2.0 SITE CHARACTERISTICS

Chapter 2, “Site Characteristics,” of the Turkey Point Units 6 and 7 combined license (COL) final safety analysis report (FSAR) addresses the geological, seismological, hydrological, and meteorological characteristics of the Turkey Point Units 6 and 7 site and vicinity, in conjunction with present and projected population distribution and land use and site activities and controls.

2.0.2 Summary of Application

Figure 2.5.1-13. Profile 20 as interpreted from Kula, 2014.

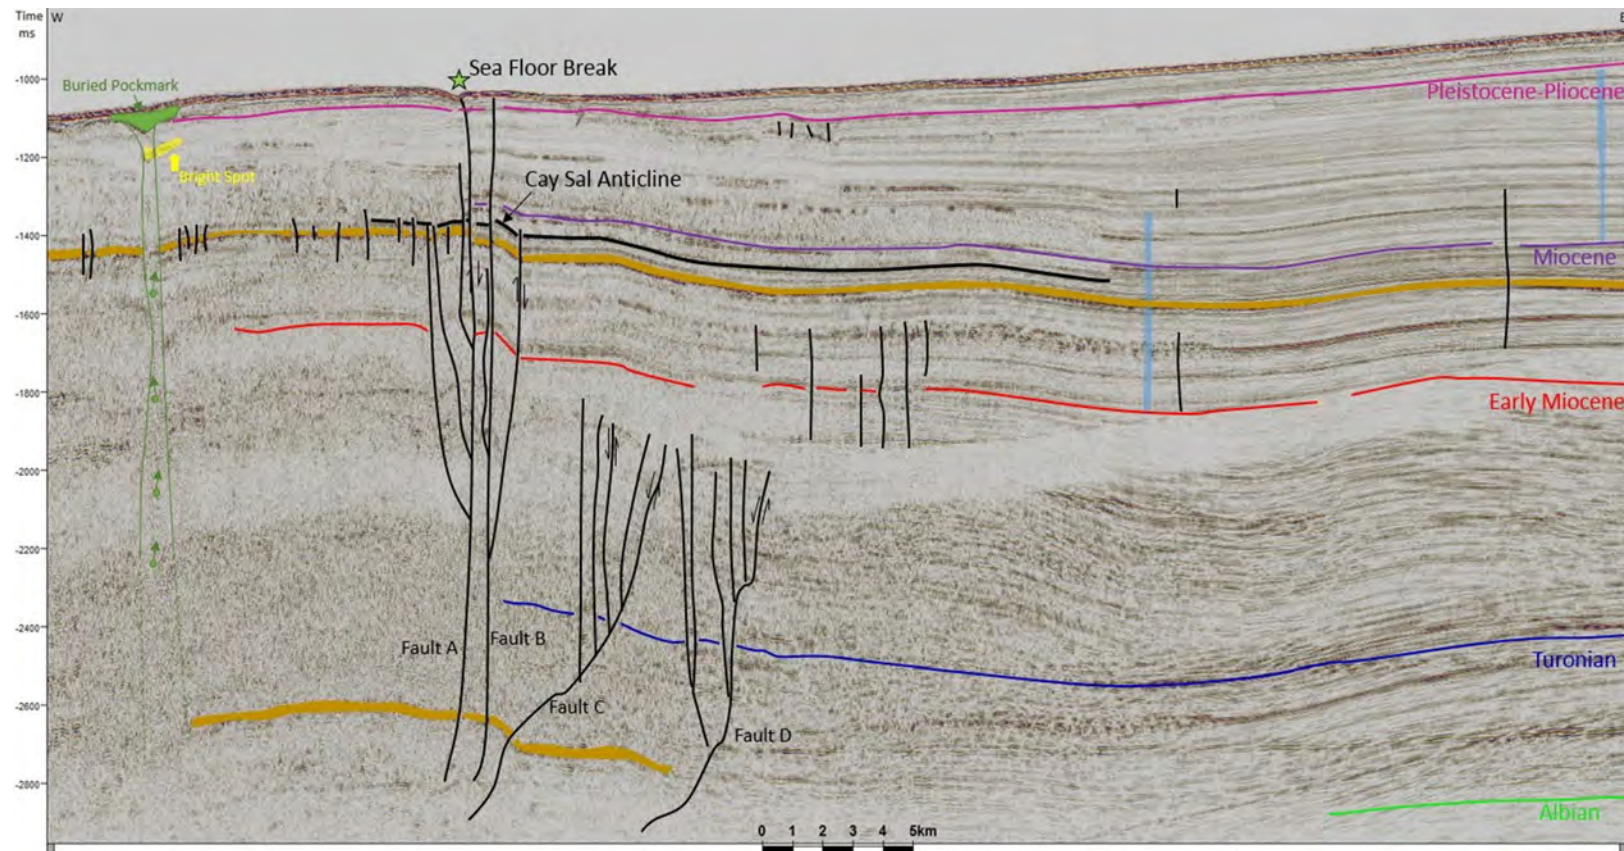
Based upon all the material that the staff reviewed related to this question, the staff decided to conduct its own seismic hazard sensitivity analysis. The applicant provided a synopsis of Kula's (2014) interpretation of four tectonic faults along the eastern margin of Cay Sal Bank, and her interpretation that these faults represent an extension of the Cuba Fold and Thrust Belt a few hundred kilometers farther north and east than previously mapped by others. Kula suggests neotectonic activity on two of these faults (Fault A and B) along the eastern margin of Cay Sal Bank and north to the Straits of Florida. Kula (2014) interprets that the faults extend in length

Figure 14. Fault Maps of Cuba Showing Earthquakes from the Project Phase 2 Earthquake Catalog (Sheet 1 of 3) (Turkey Point Units 6 and 7 COL FSAR Figure 2.5.1-368). Multiple sources used to compile this map, including Turkey Point Units 6 and 7 COL FSAR Refs. 439, 448, 492, and 494.

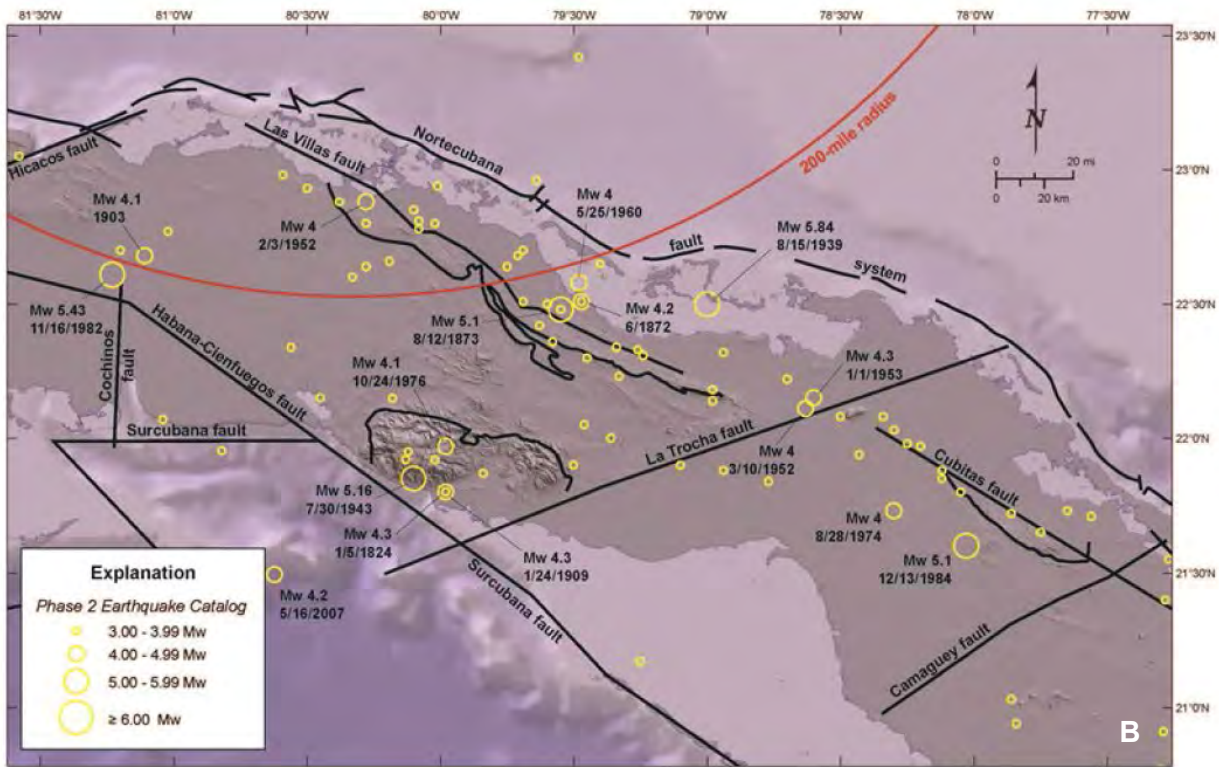
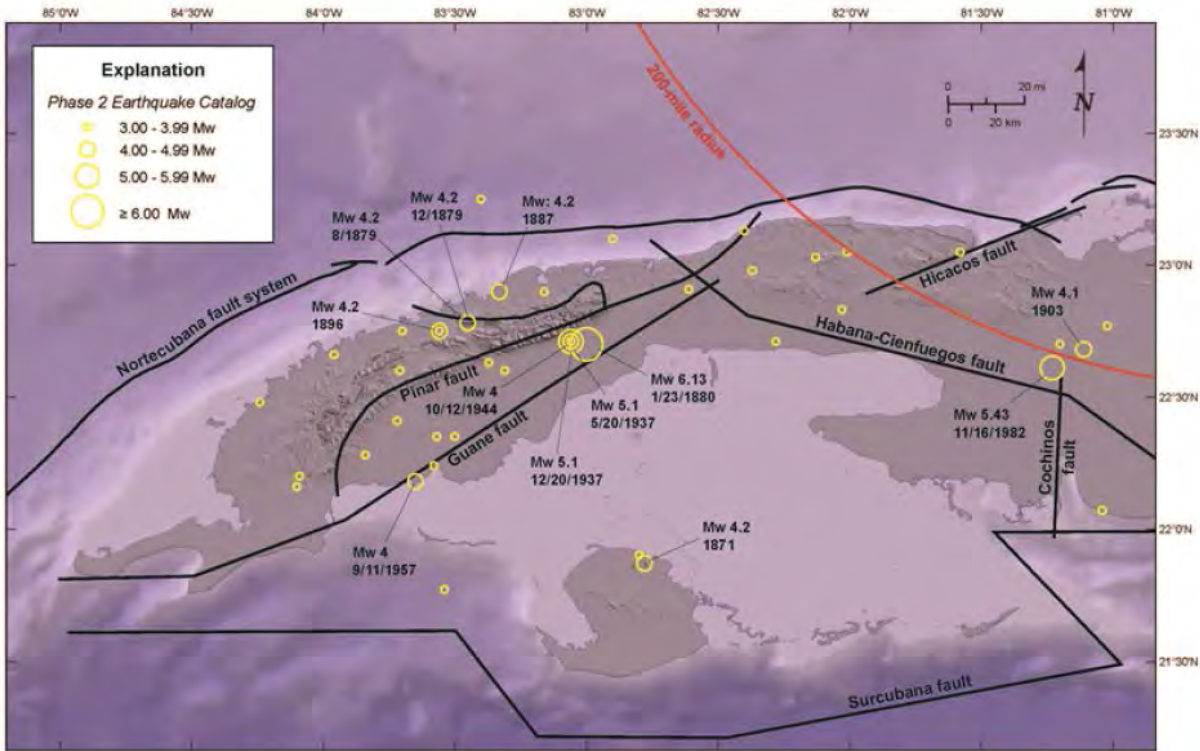
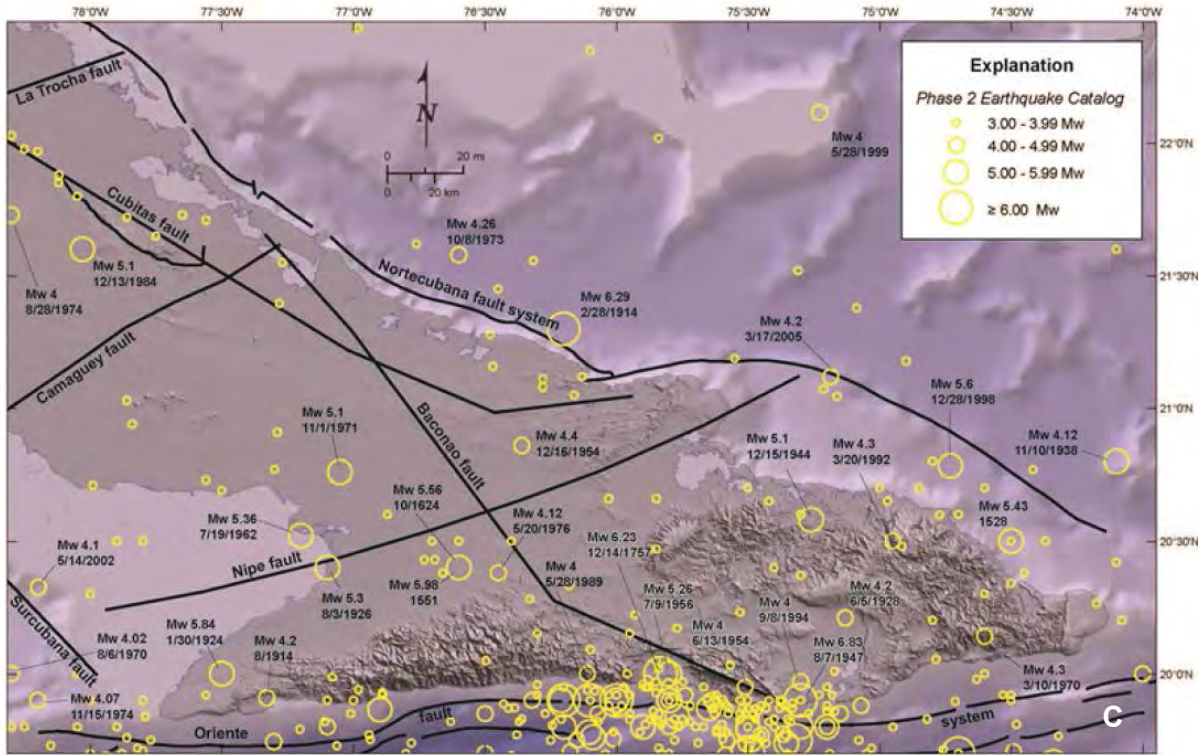
In response to several RAIs regarding Cuba faults and seismicity (RAI 41, Questions 02.05.01-21, -24 through 30) (ADAMS Accession Nos. ML14282A078, ML14282A079, and ML14282A079) dated October 3, 2014, the applicant made a general statement that the lack of permanent seismic recording stations in Cuba, especially for lower-magnitude earthquakes, limits the accuracy of earthquake locations; that earthquakes in Cuba do not appear to correlate strongly with faults; and the Phase 2 earthquake catalog was used to consider the possibility of seismicity associated with a specified fault (Figure 2.5.1-14). The staff notes that the Phase 2

In a June 8, 2015 response to RAI 81, Question 02.05.01-35 (ADAMS Accession No. ML15160A574) the applicant responded that a declustered or mainshock Phase 2 earthquake catalog was used to compute recurrence parameters for the Cuba seismic source characterization. The applicant agrees with the staff that in the Cuba region that mapping seismicity before the declustering earthquake process could be used in identifying potentially active, previously unidentified structures, if the earthquake association were unambiguous. Therefore, the applicant revised FSAR Figure 2.5.1-368 (Sheets 1 through 3) to include mainshock events of Mw and above 3.0, and foreshocks, aftershocks, and cluster events of Mw and above 3.0, and all small events mainshock and dependent events of Mw less than 3.0. The applicant also stated that the relevant text in Turkey Point Units 6 and 7 COL FSAR Section 2.5.1 will be revised accordingly. The applicant also stated that while the majority of the small-magnitude (Mw less than 3) seismicity is scattered and diffuse, seismicity patterns do show several clusters that are not part of the Phase 2 mainshock earthquake catalog Mw of 3 and above. Some of these earthquakes are not of sufficient size and definition to merit their consideration as fault sources. Other earthquake clusters are near faults that were included in a PSHA sensitivity study of the modeling of Cuba as a seismic source. The applicant concluded that when specific faults were considered as alternatives to the Cuba seismic source, they produced negligible impact on the total seismic hazard at the Turkey Point Units 6 and 7 site, as compared to the modeling of Cuba as a single areal seismic source zone (see FSAR Section 2.5.2.4.4.3.4.2.1). The staff evaluates the sensitivity analysis for the Cuba seismic source in RAI 41, Question 02.05.01-21 and RAI 5896, Question 02.05.02-4. Staff considers the revised Turkey Point Units 6 and 7 COL FSAR Figure 2.5.1-368 showing the total earthquake catalog of independent and dependent earthquakes sufficient response to this question and thus considers RAI 81, Question 02.05.01-35 resolved.
